# Staff Report

## Site Plan Review

SP-05-24

Proposal:	To construct a new 3,000-square-foot accessory structure.
Review Body:	Staff (Type I-L review)
Applicant/Property Owner:	Brian Sanchez Garcia; 3521 Bernard Avenue NE, Albany, OR 97322
Address/Location:	3521 Bernard Avenue NE, Albany, OR 97322
Map/Tax Lot:	Linn County Tax Assessor's Map No. 10S-03W-33DB Tax Lot 00500
Zoning:	Residential Single Dwelling (RS-6.5)
Overlay Districts:	None
Total Land Area:	23,760 square feet
Existing Land Use:	Residential
Neighborhood:	East Albany
Surrounding Zoning:	North: Residential Single Dwelling (RS-6.5) East: RS-6.5 South: RS-6.5 West: RS-6.5
Surrounding Uses:	North: Single-dwelling unit residential East: Single-dwelling unit residential South: Single-dwelling unit residential West: Single-dwelling unit residential

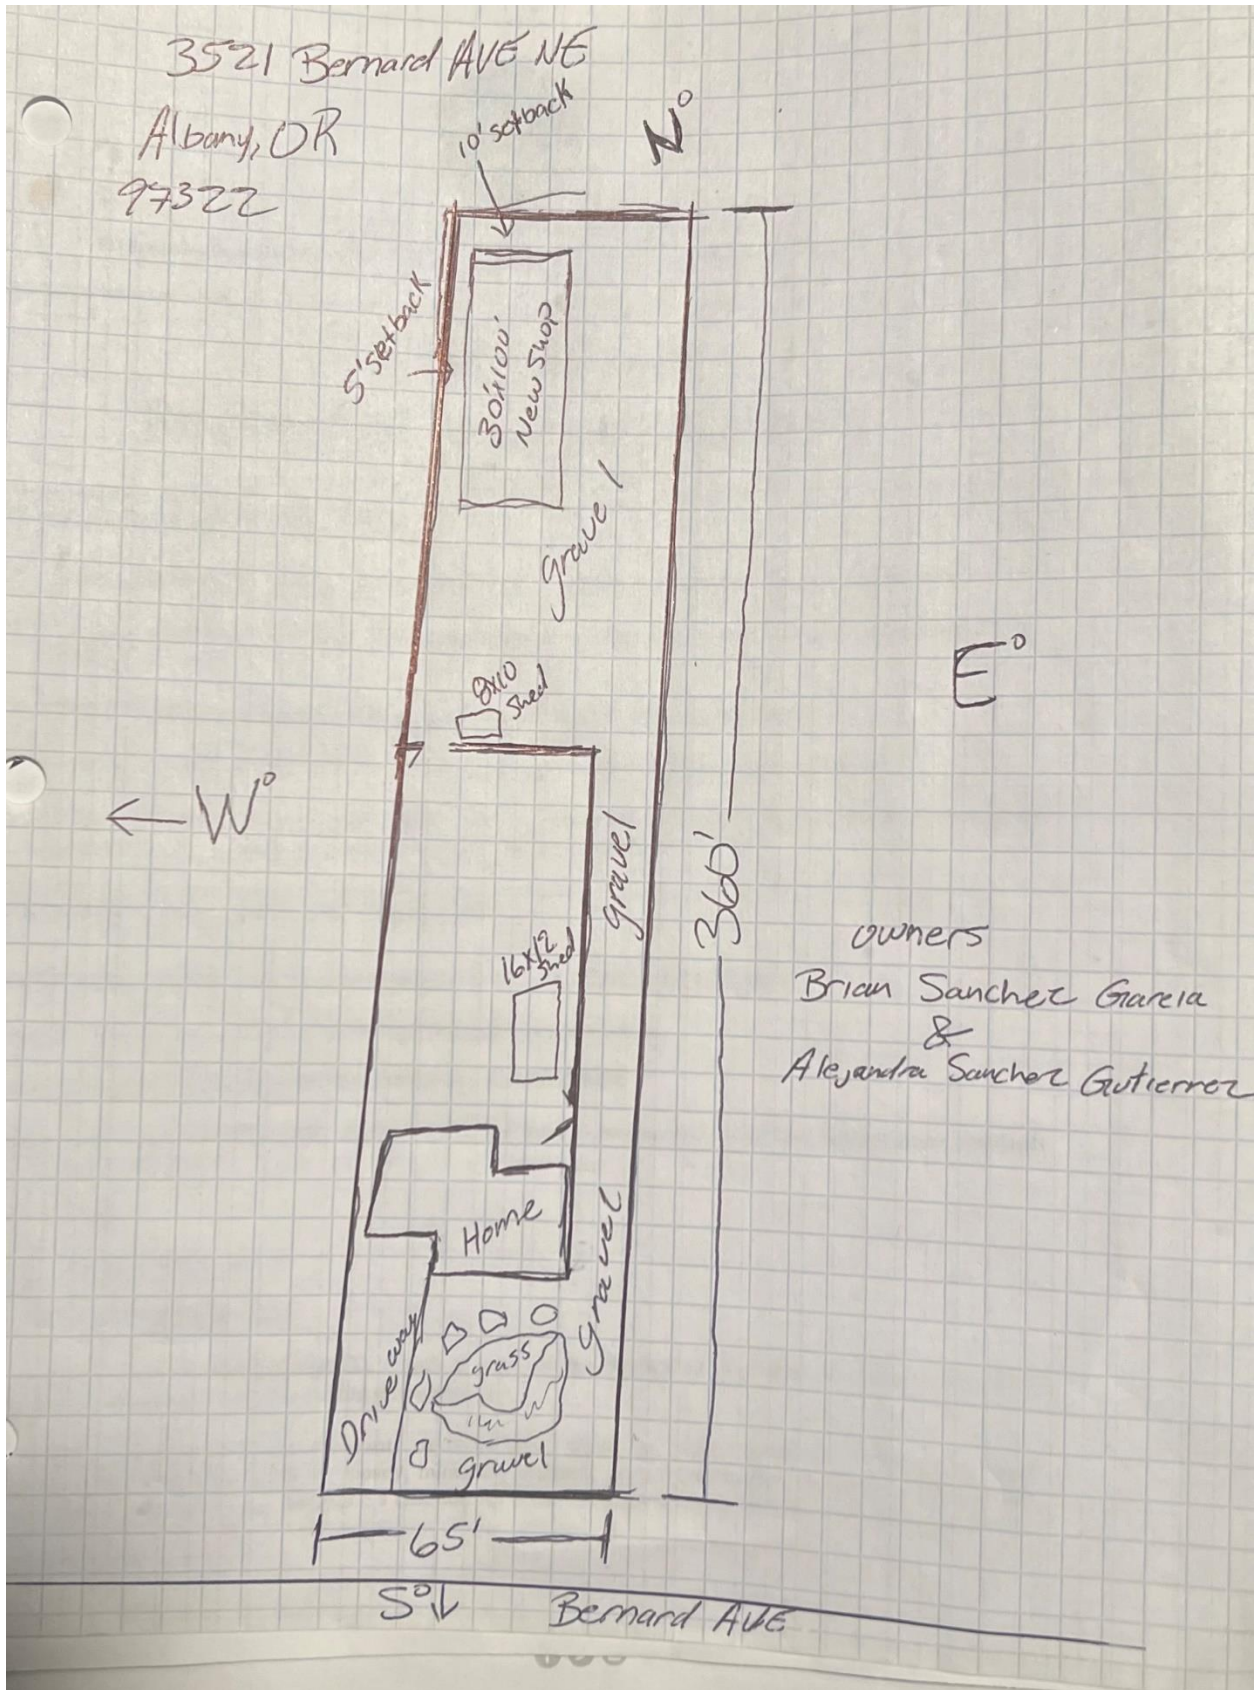
- 2.3 The submitted site plan (Attachment B) indicates the proposed accessory building will meet the minimum front setback of 20 feet and the interior setback of five feet.

- 2.4 The lot dimensions do not change with the proposed accessory structure.
- 2.5 Per ADC Table 3.190-1, the total lot coverage allowed in the RS-6.5 zone is 60 percent. Lot coverage for detached single dwelling development only includes the area of the lot covered by buildings or structures. The subject property is 23,760 square feet with an existing dwelling at 1,056 square feet and two existing sheds totaling 272 square feet. The proposed accessory building will increase the lot coverage to 18 percent.

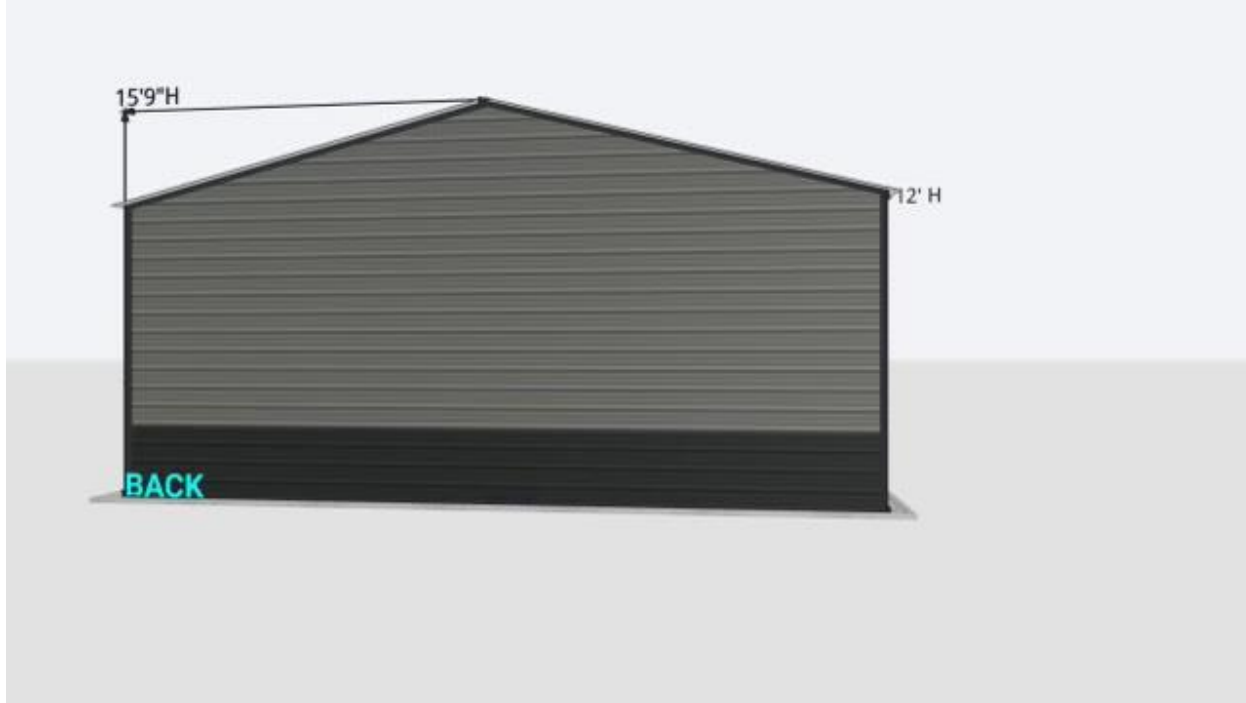
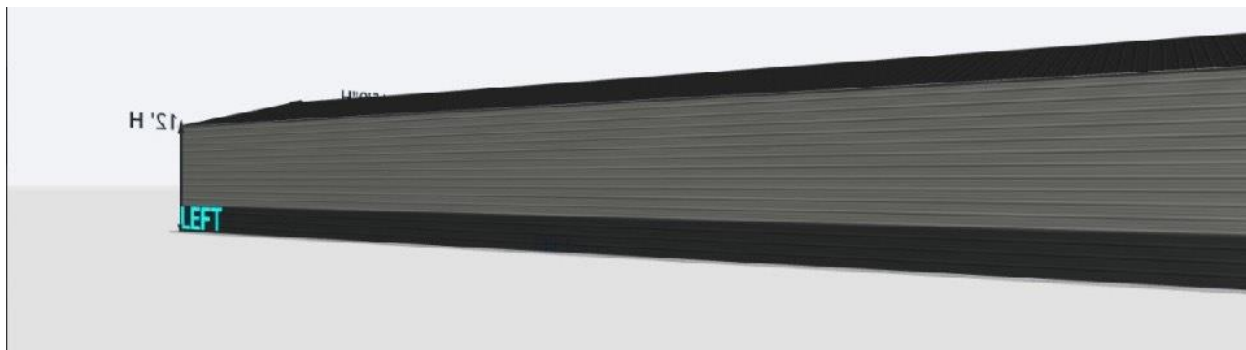
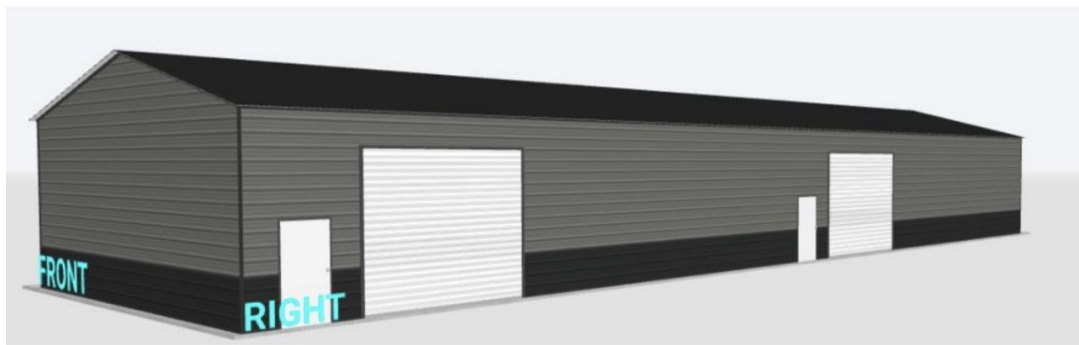
- 2.6 Per ADC Table 3.190-1, the maximum height allowed in the RS-6.5 zone is 30 feet. ADC 22.400 "Height of Building" defines the height of a pitched roofed building as the average height of the highest gable of a pitched roof. The total height of the proposed structure is approximately 16 feet and a wall height of 12 feet.
